Title - Sujet Steamboat Maintenance Camp Remed.	
Solicitation No. - N° de l'invitation EZ113-191032/A	Amendment No. - N° modif. 003
Client Reference No. - N° de référence du client	Date 2018-08-22
GETS Reference No. - N° de référence de SEAG PW-\$PWY-019-8401	
File No. - N° de dossier PWY-8-41074 (019)	CCC No./N° CCC - FMS No./N° VME
Solicitation Closes - L'invitation prend fin at - à 02:00 PM on - le 2018-08-28	Time Zone Fuseau horaire Pacific Daylight Saving Time PDT
F.O.B. - F.A.B. Plant-Usine: <input type="checkbox"/> Destination: <input checked="" type="checkbox"/> Other-Autre: <input type="checkbox"/>	
Address Enquiries to: - Adresser toutes questions à: Ngan, Ken (PWY)	Buyer Id - Id de l'acheteur pwy019
Telephone No. - N° de téléphone (604) 671-0219 ()	FAX No. - N° de FAX (604) 775-6633
Destination - of Goods, Services, and Construction: Destination - des biens, services et construction: PWGSC - Steamboat Maintenance Camp, km 537.9 - Alaska Highway, BC

Amendment 003

This Solicitation Amendment is raised to Incorporate Addendum 001 to:

DESIGN		Steamboat Maintenance Camp, Kilometre 537.9	DATE	August 2018
DRAWN	DK	Alaska Highway, BC	SHEET No.	9 of 9
CHECKED	GS/TW	Public Services and Procurement Canada	PROJECT No.	20338
APPROVED	TW	Mill Creek Gravel Pit	REVISION No.	03
SCALE	1:2000		DRAWING No.	18-00338-08

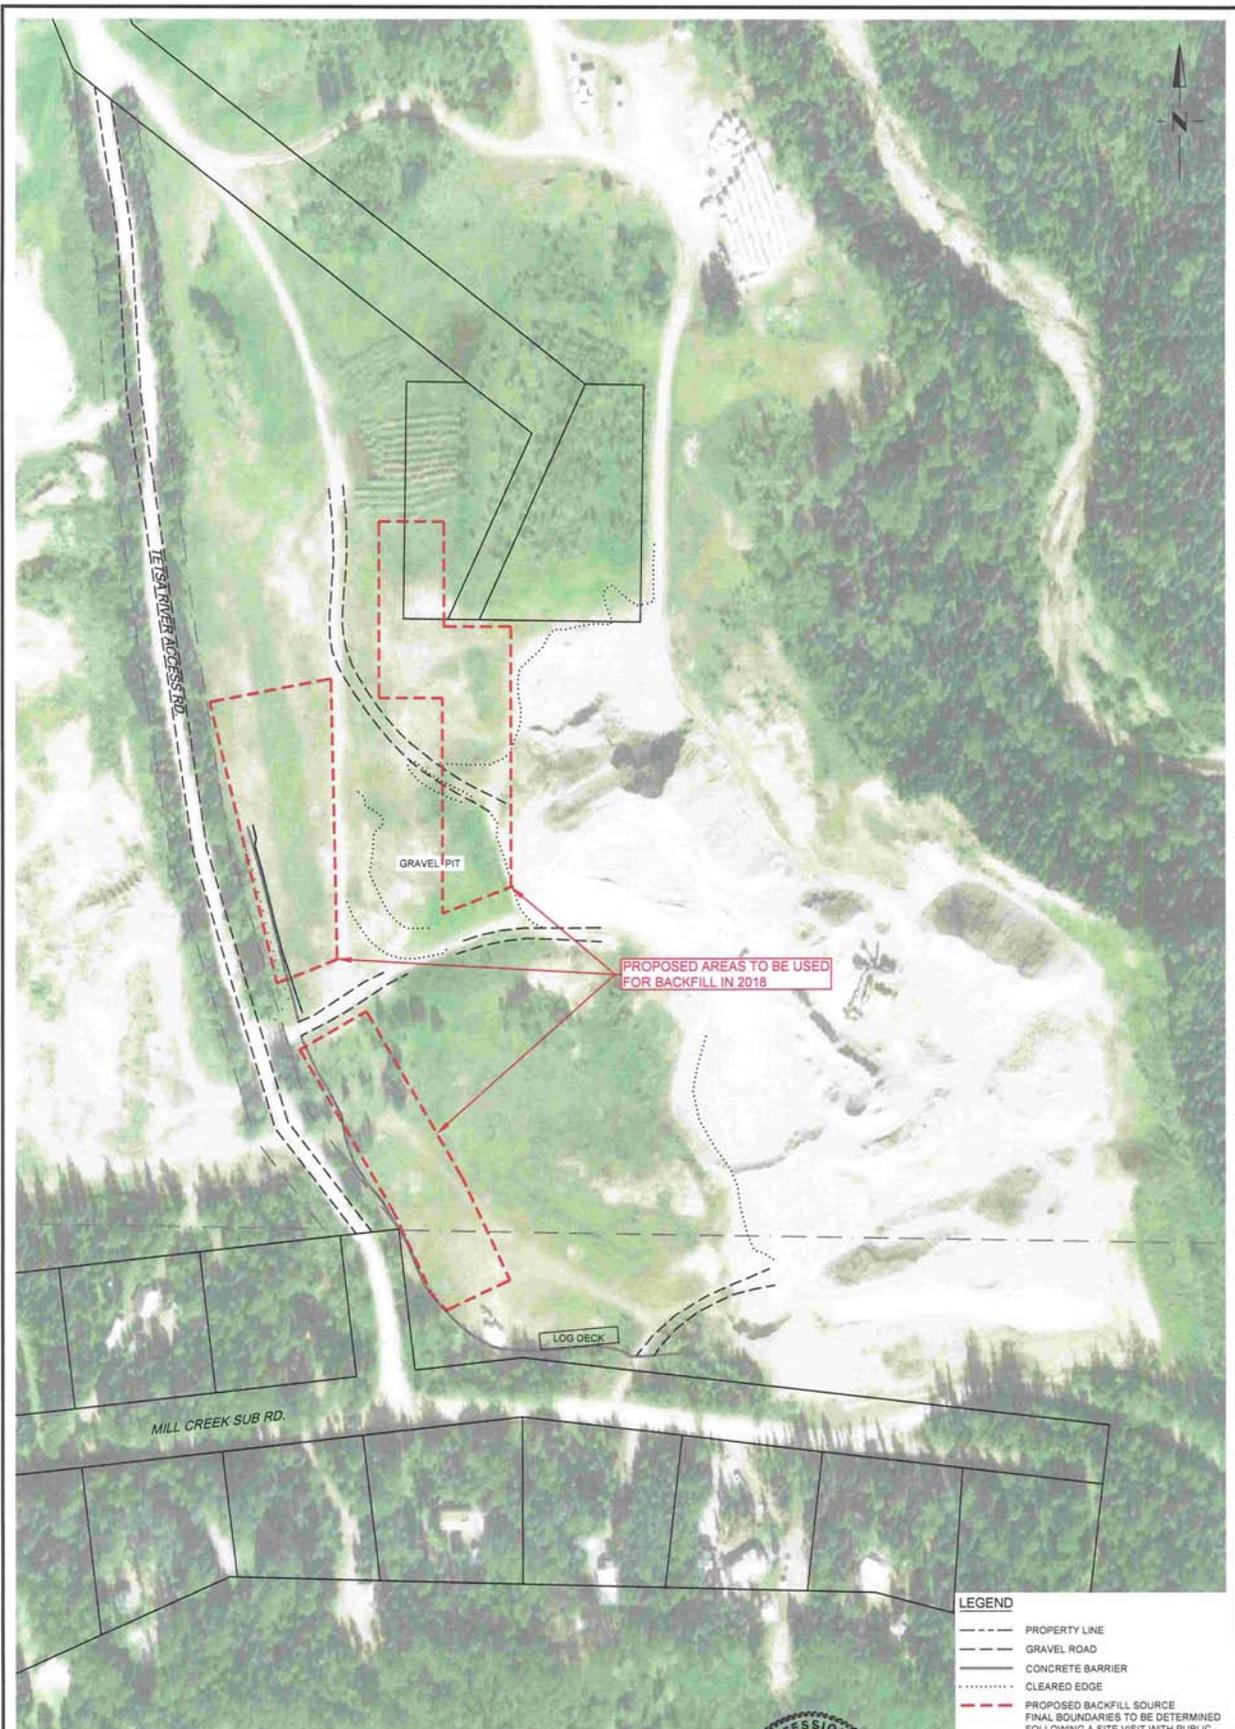
3. Are there any other areas at Mill Creek Gravel Pit that can be used for backfill?

Drawings revised for addition of third area which can be used for backfill at the Mill Creek Gravel Pit (Km 552).

1. Drawing 18-00338-08

Yes: A third area has been identified as shown on the revised drawing #18-00338-08 attached.

Replace with attached Drawing 18-0038-08-Rev03.
